**RE: Stanford Court (424 Stanford Drive SE)
Grading & Drainage Plan
Engineer's Stamp Date 2-9-16 (File: K16D084)**

**RE: Stanford Court (424 Stanford Drive SE)
Grading & Drainage Plan
Engineer's Stamp Date 1-7-16 (File: K16D084)**

Re: Stanford Court
424 Stanford Dr., SE
Traffic Circulation Layout
Engineer's/Architect's Stamp 3-2-16 (K16-D084)

Figure 1. Mini Clear Sight Triangle

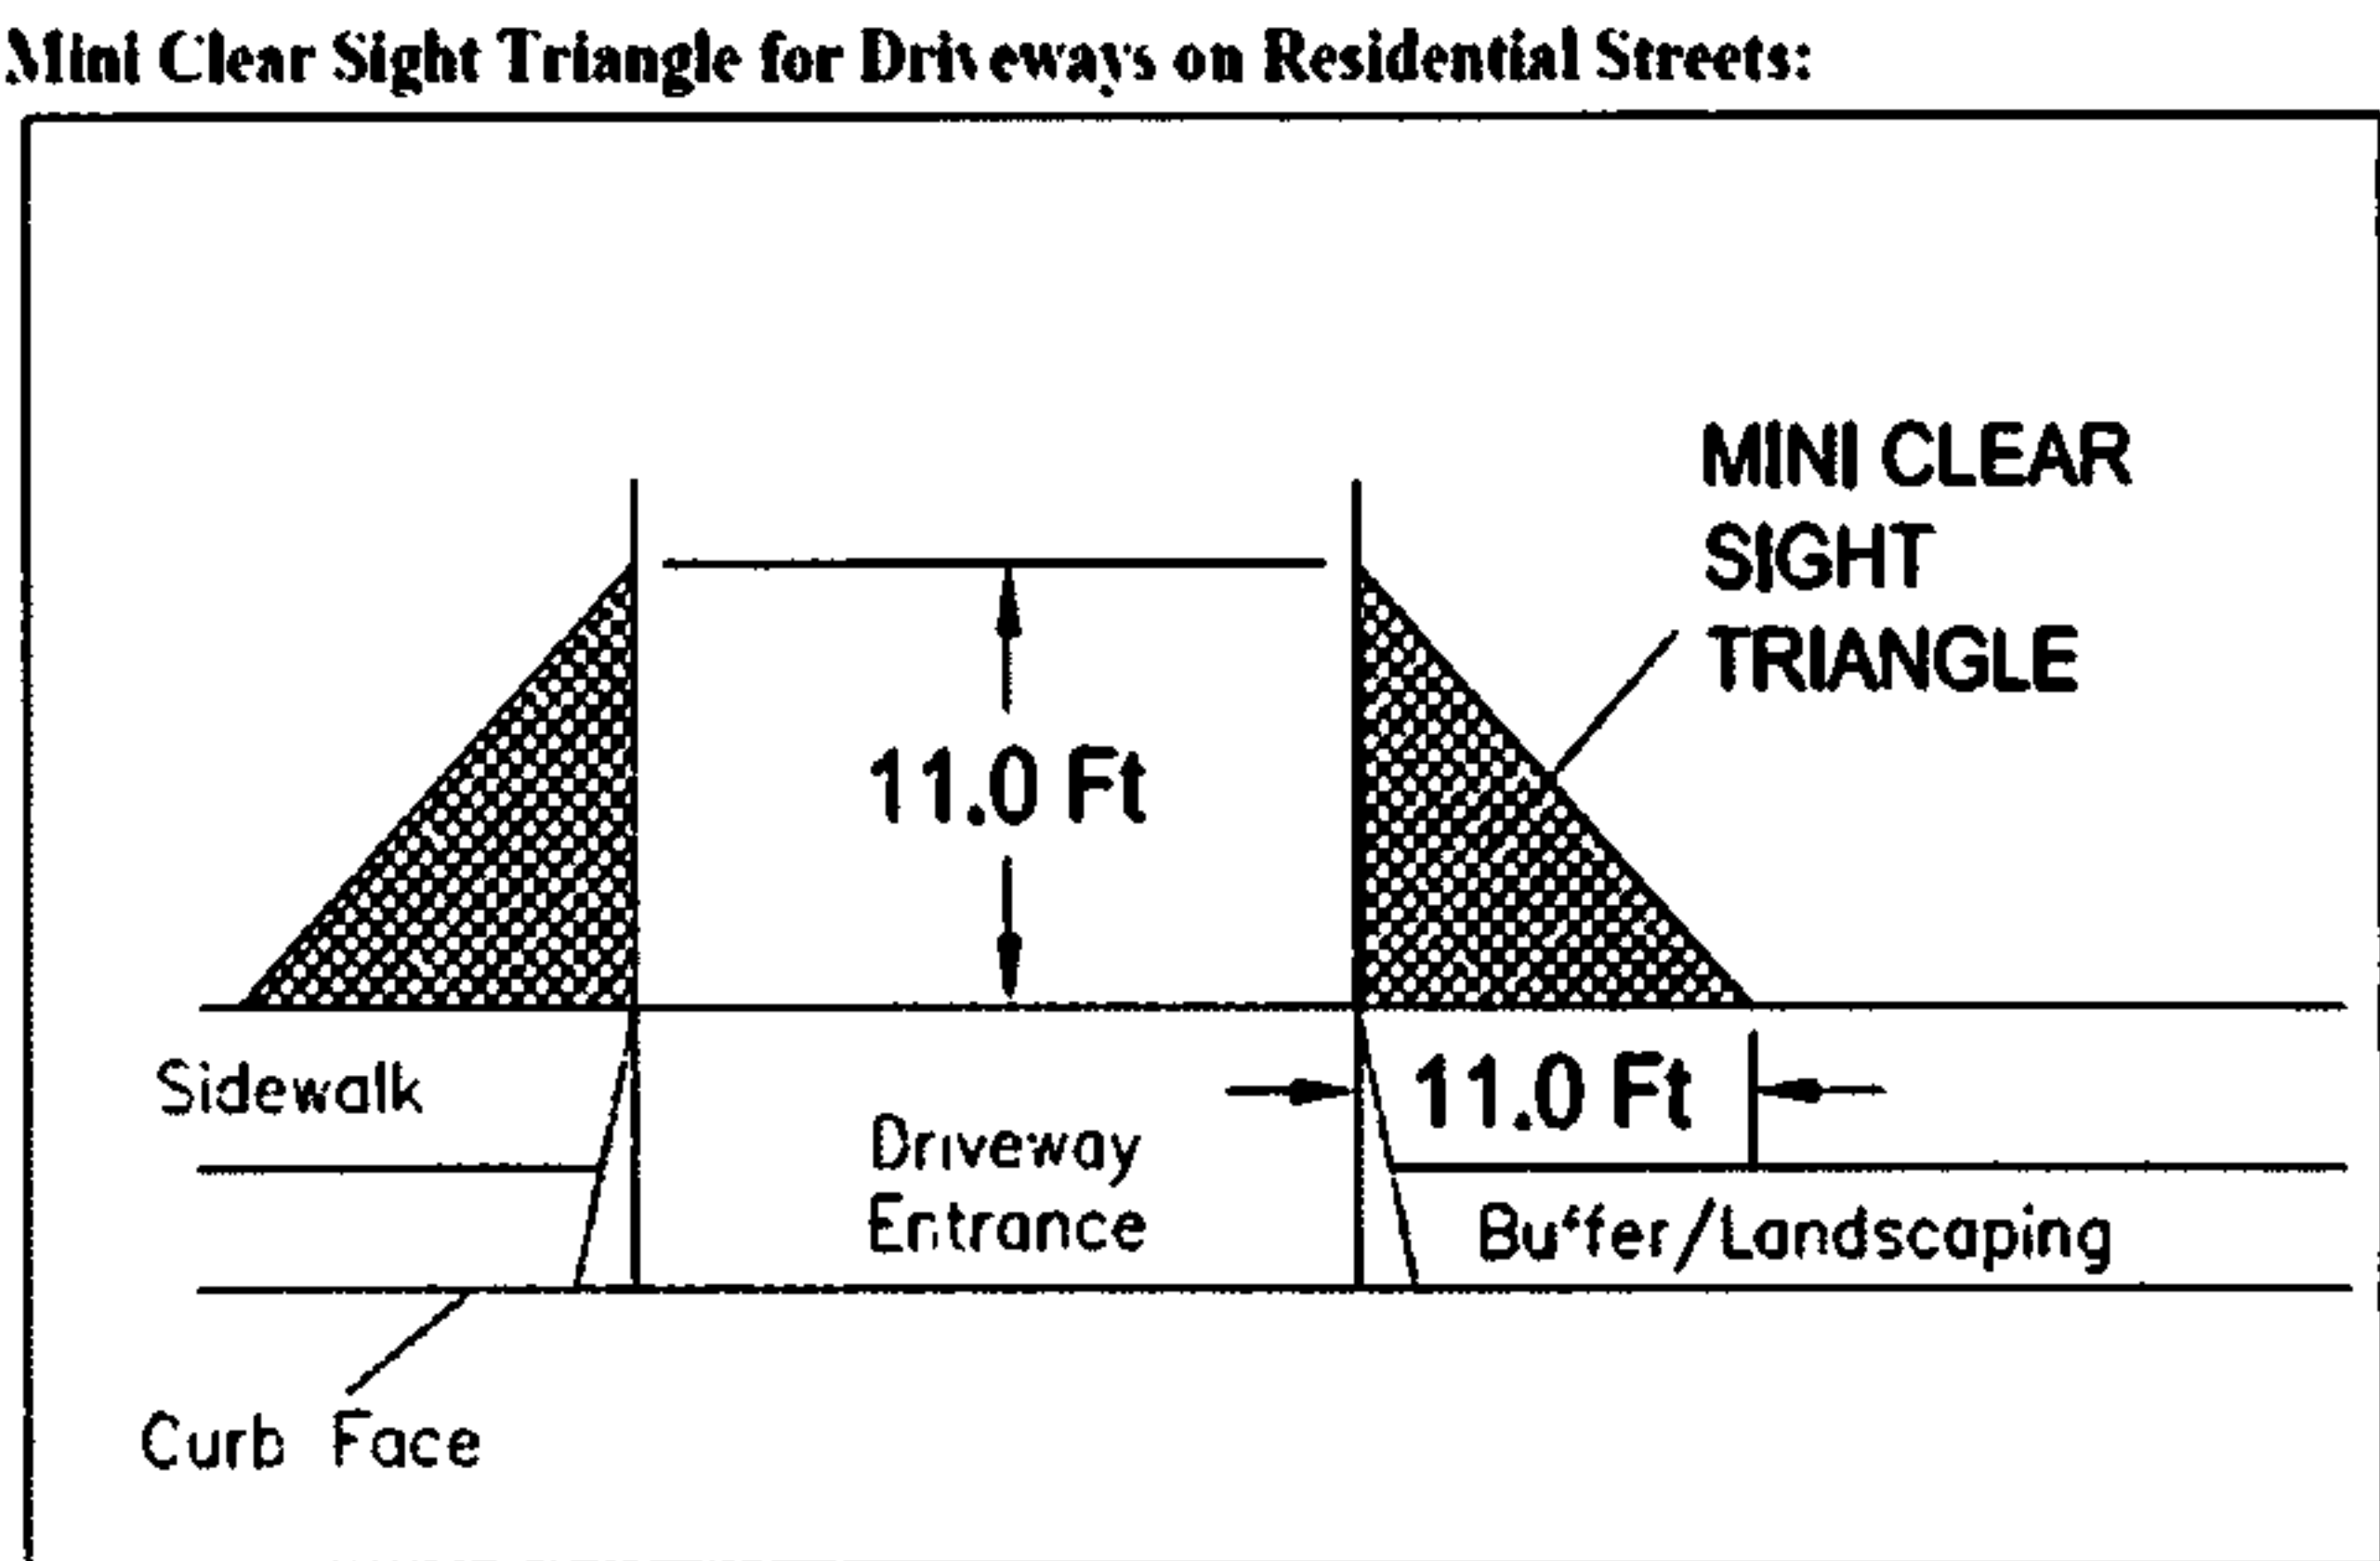
11. Please provide a Mini Clear Sight distance exhibit (see the *Development Process Manual, Chapter 23, Section 3*.) for the entrance/exit off of the public alley on the east side of the project site.

12. Please add the following note to the clear sight triangle: “Landscaping and signage will not interfere with clear sight requirements. Therefore, signs, walls, trees, and shrubbery between 3 and 8 feet tall (as measured from the gutter pan) will not be acceptable in this area.”
13. All broken or cracked sidewalk must be replaced with sidewalk and curb & gutter. A build note must be provided referring to the appropriate City Standard drawing.
14. Please include two copies of the traffic circulation layout at the next submittal.
